Overview: Production error in version 1.0 harnesses; The immobilizer wire (orange/black) is in pin position #4 instead of pin position #5. Although an effort to correct the issue was made, some quantity of harnesses did get shipped before the issue was spotted. We are advising to inspect the harness BLADE connector before attempting to install harness or program the module. This issue is not known to affect the version 2 harnesses, which require no modification.

MODIFICACIÓN REQUERIDA PARA APLICACIONES A/T, SÓLO CON ARNÉS v 1.0

FTI-STP1: Notas de instalación y configuración

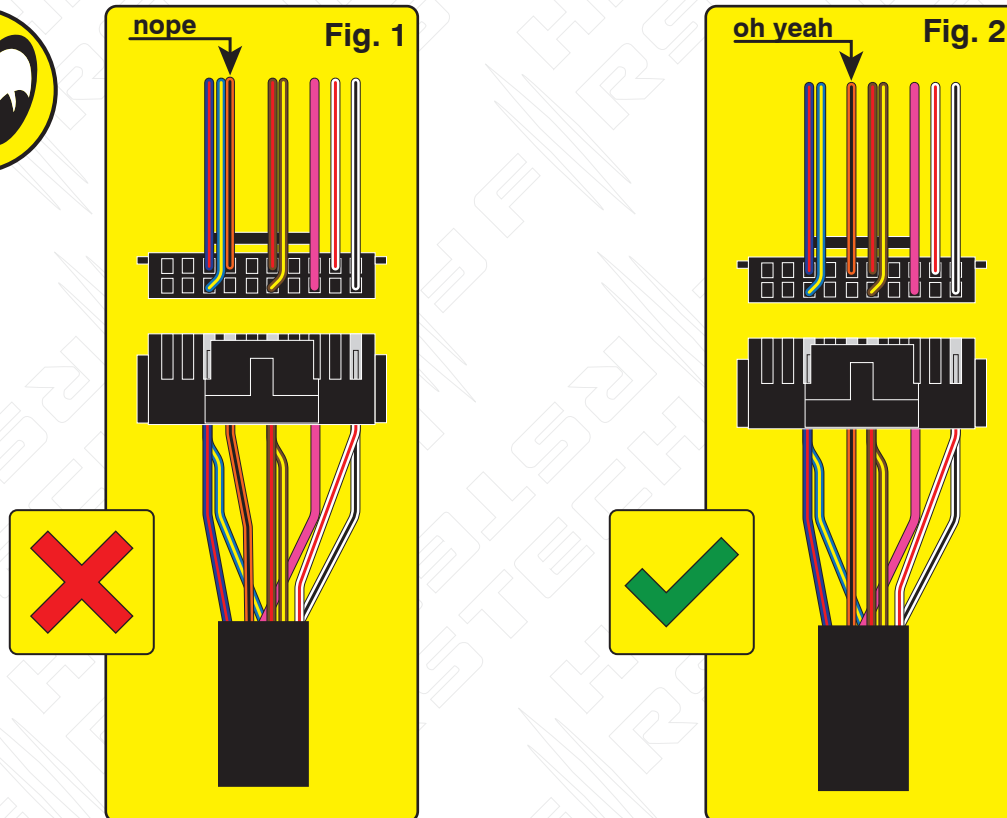
Issue: Module fails to program correctly to vehicle, does not allow the vehicle to be remote started.

Correction: Step 1.) Locate the orange/black wire and confirm whether it is positioned as illustrated in Fig. 1 or Fig. 2. If the wire is as illustrated in Fig.1, proceed with Step 2 through 5 and complete the repair procedure outlined, if the wire is as illustrated in Fig. 2, correction is not necessary, proceed with harness installation and module programming.

Step 2.) Using a pick, lightly depress the catch that secures the terminal in the housing then remove the wire and terminal from the housing.

Step 3.) Using a fine tip razor or utility knife, insert the blade beneath the terminal catch and raise it slightly, so that it can be reused to secure the terminal when reinserted into the BLADE connector housing.

Step 4.) Refer to Fig. 2 for correct position of the orange/black wire (next to brown/red) then reinsert the terminal, pressing lightly until the catch 'snaps' into place, securing the terminal in the connector housing.

Step 5.) The repair is complete, proceed with installation and programming.

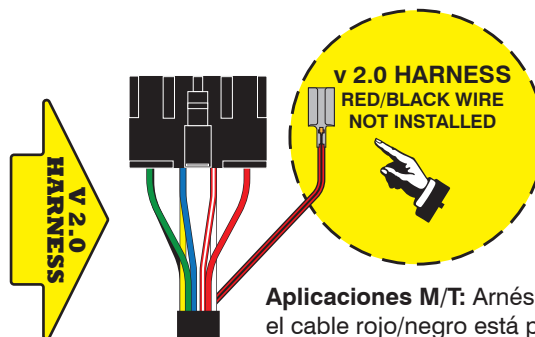
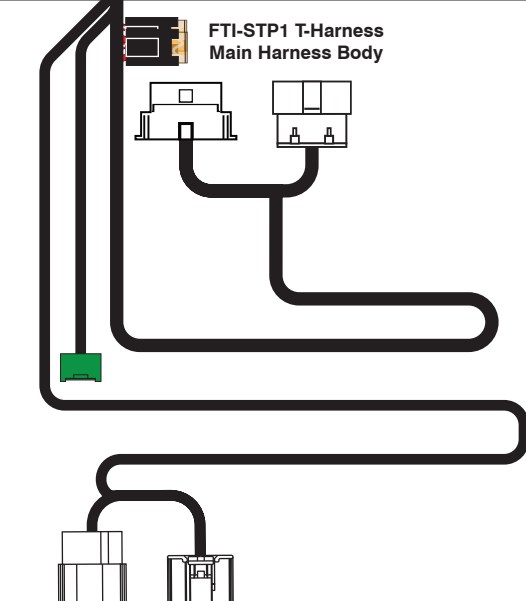
Problema: El arnés en T FTI-STP1 ha sido diseñado para ser compatible con A/T (transmisión automática) y M/T (manual), pero debido a un descuido en las primeras ejecuciones de producción, la selección se estableció por defecto en el modo M/T.

El uso de un arnés configurado para una aplicación M/T, en un vehículo equipado con A/T, podría provocar daños en el módulo del vehículo, se recomienda que el arnés vuelva al modo A/T antes de la instalación en vehículos equipados con transmisión automática.

Corrección: Localice el cable rojo/negro (+ embrague) proporcionado en el conector CN1 del conjunto del arnés principal. Corte el cable rojo/negro, ya sea al ras del conector CN1 o dejando suficiente cable expuesto para que pueda aislar y asegure los extremos del cable que quedan después del corte. Aísle cada uno de los extremos restantes del cable rojo/negro y asegúrelos para evitar cualquier posibilidad de cortocircuito. Si el cable rojo/negro ya ha sido desconectado, ninguna modificación adicional se requiere para aplicaciones A/T

NO SE REQUIERE MODIFICACIÓN CUANDO SE UTILIZA FTI-STP1 (v 1.0) ARNÉS EN APLICACIONES M/T, O CUANDO UTILICE EL ARNÉS FTI-STP1 (v 2.0)

Aplicaciones M/T: Arnés versión 2.0, el cable rojo/negro está pegado al arnés principal cuando se envía, y debe instalarse en el CN1 conector cuando está instalado.

Aplicaciones A/T: Deje el cable rojo/negro pegado al arnés, no es necesario para aplicaciones A/T
